HARTZELL PROPELLER INC.
SERVICE BULLETIN
TRANSMITTAL SHEET
HC-SB-61-377
Propeller - Blade Seal Replacement

January 08, 2019

HARTZELL PROPELLER INC.
SERVICE BULLETIN
HC-SB-61-377
Propeller - Blade Seal Replacement

Blade Seal Inspection
Figure 1

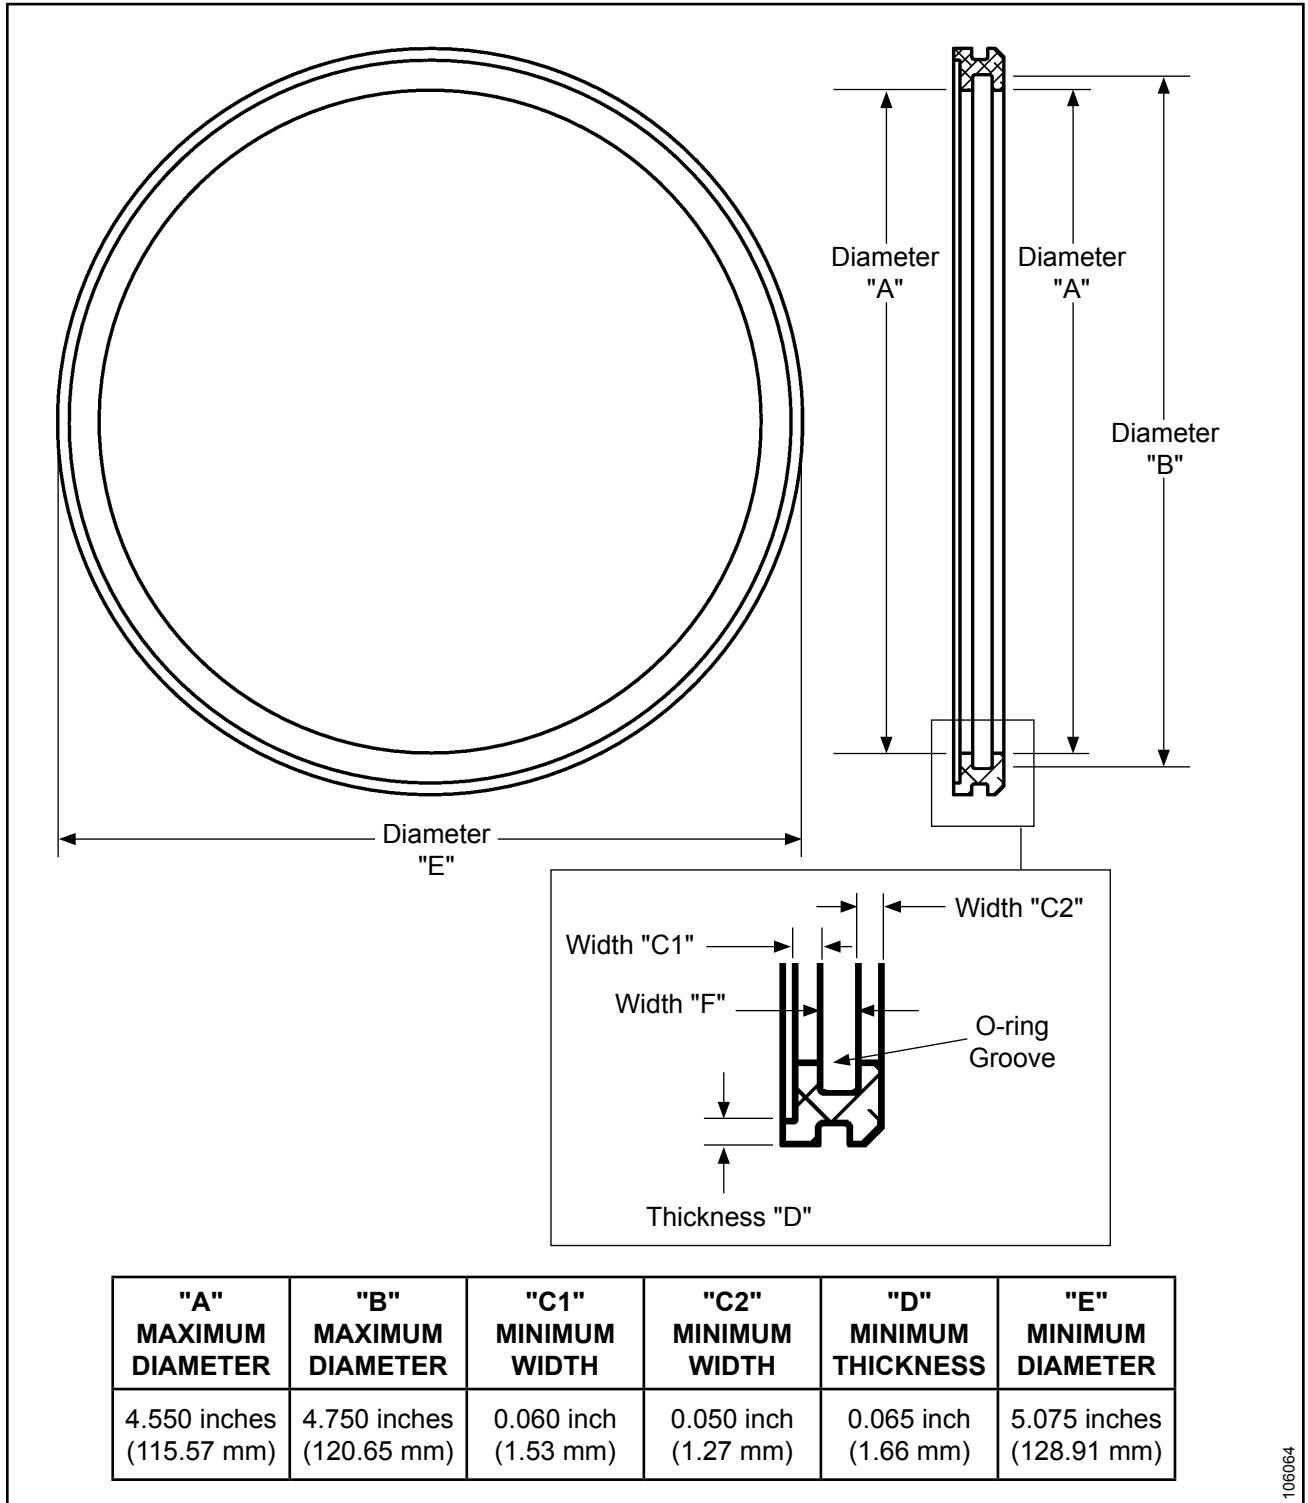
(2) Measure the O-ring groove width "F".	The maximum permitted width of O-ring groove "F" is 0.175 inch (4.44 mm).	If the O-ring groove width "F" is greater than the permitted serviceable limits, replace the blade seal.

(3) Measure the O-ring groove width "F" for uniform width variation.	The maximum permitted width variation of O-ring groove "F" is 0.015 inch (0.38 mm).	If the width variation of O-ring groove "F" is greater than the permitted serviceable limits, replace the blade seal.

(4) Measure the pre-load plate seal housing features "A", "B", "C1", "C2", "D", and "E".	The permitted limits are given in the table in Figure 1.	If any measurement is not within the permitted serviceable limits, replace the blade seal.

106136 Pitch Change Block Button Modification
Figure 2

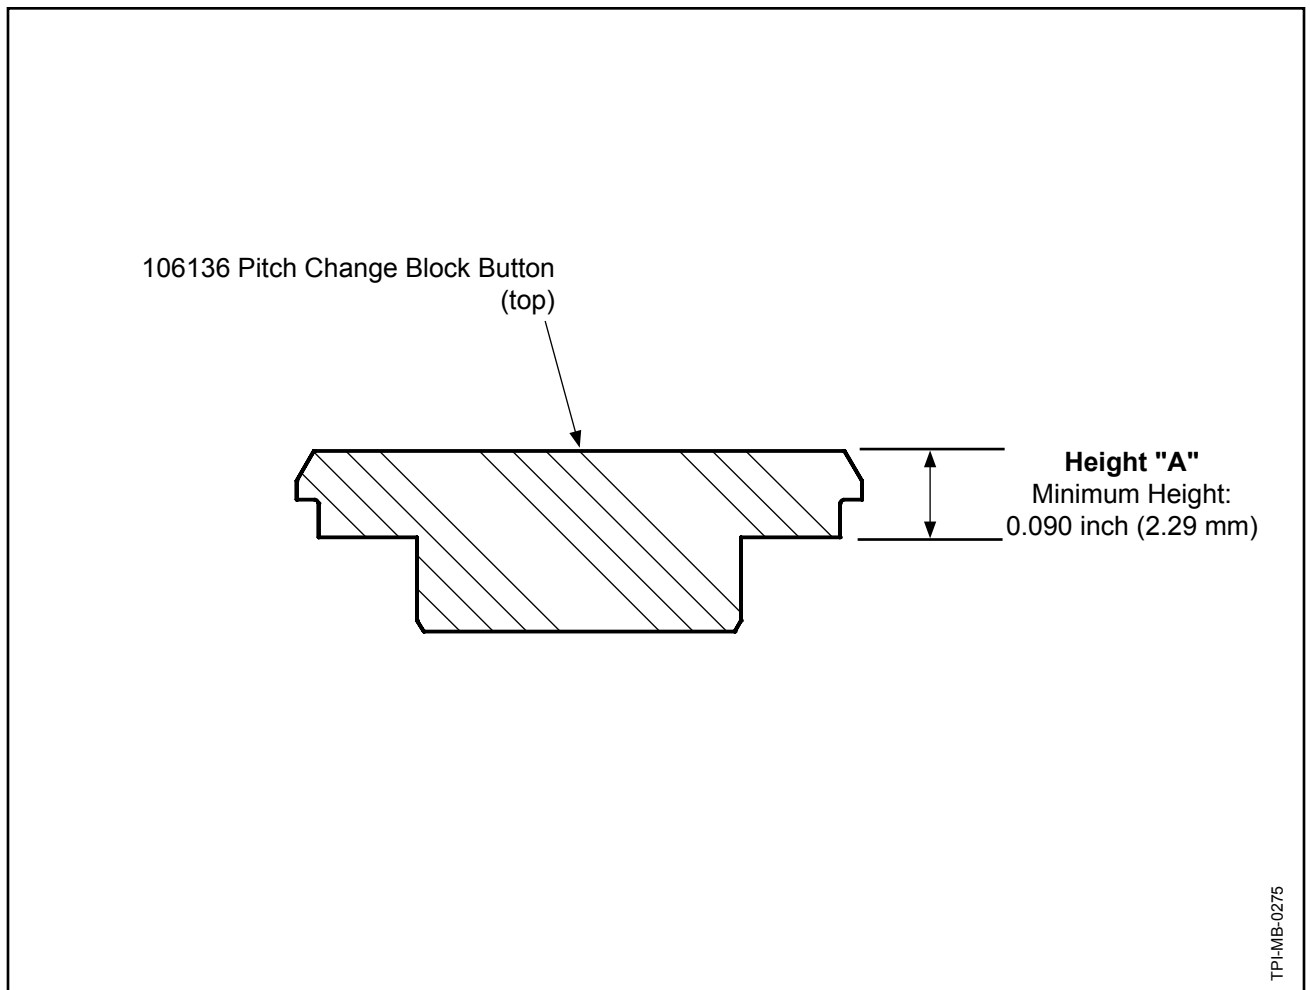
- Revised the minimum Height "A" dimension in the section, "106136 Pitch Change Block Button Modification"

- (2) Hartzell Propeller Inc. is introducing a redesigned 106136 pitch change block button that is thinner than the previous design. The thinner pitch change block button can improve the response rate of the propeller when going from high pitch to low pitch.
 - (a) The height "A" of the redesigned 106136 pitch change block button is 0.115 ±0.005 inch (2.92 ±0.12 mm). Refer to Figure 2.

- (1) To improve the response rate of the propeller when going from high pitch to low pitch, modify the 106136 pitch change block buttons in accordance with the following steps.
 - (a) Using an abrasive pad CM47, sandpaper, or equivalent, polish the top surface of the 106136 pitch change block button to reduce the height "A" of the button. Refer to Figure 2.
 - 1 The minimum permitted height "A" of the 106136 pitch change block button is 0.090 inch (2.29 mm).
